Access Compliance Report

Public Rights-of-Way

(Curb Ramps)

Intersection ID: 12828	Main Street: W_MOREHEAD_ST	Cross Street: S_CHURCH_ST	Location: SE
ADA ID: A2D333D44994	Ramp Type: PerpDiag	Initial Pass/Fail: Fail	Overall Compliance: No
			Severity Score: 13.75

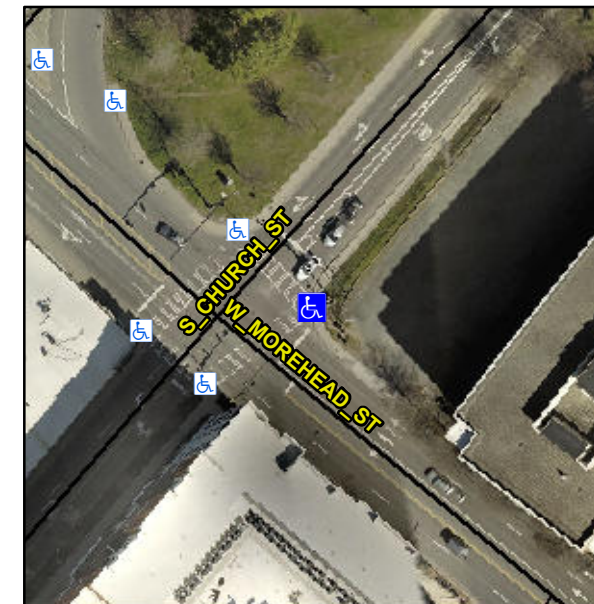
Not Found, R304.2.2

Compliance	Description	Data	Compliance	Description	Data
N/A	Ramp Length (in)	59.0	No	Ramp Slope (%)	8.9
Yes	Ramp Width (in)	48.0	Yes	Ramp XSlope (%)	2.4
N/A	Flare Type LT	N/A	N/A	Flare Type RT	N/A
N/A	Flare Slope LT (%)	N/A	N/A	Flare Slope RT (%)	N/A
N/A	Flare Traversable LT?	N/A	N/A	Flare Traversable RT?	N/A
N/A	Landing Length (in)	N/A	N/A	DWS Provided?	N/A
N/A	Landing Width (in)	N/A	N/A	DWS Contrast?	N/A
N/A	Landing Slope (%)	N/A	N/A	DWS Length (in)	N/A
N/A	Landing X Slope (%)	N/A	N/A	DWS Full Width?	N/A
N/A	Landing Curb? (Y/N)	N/A	N/A	DWS Offset (in)	N/A
N/A	Shared Landing?	N/A			
N/A	Gutter Ponding?	N/A	N/A	Gutter Slope (%)	N/A
N/A	Gutter Lip Ht (in)	N/A	N/A	Gutter X Slope (%)	N/A
N/A	Painted X Walk1?	Yes	N/A	Painted X Walk2?	Yes
	X Walk 1 Direction	To NW		X Walk 2 Direction	To SW
N/A	X Walk 1 Width (in)	100.0	N/A	X Walk 2 Width (in)	99.0
	X Walk 1 Slope (%)	0.9		X Walk 2 Slope (%)	1.5
	X Walk 1 X Slope (%)	2.2		X Walk 2 X Slope (%)	1.9

Remove & Replace Curb Ramp With Two New Directional Ramps or Equivalent.
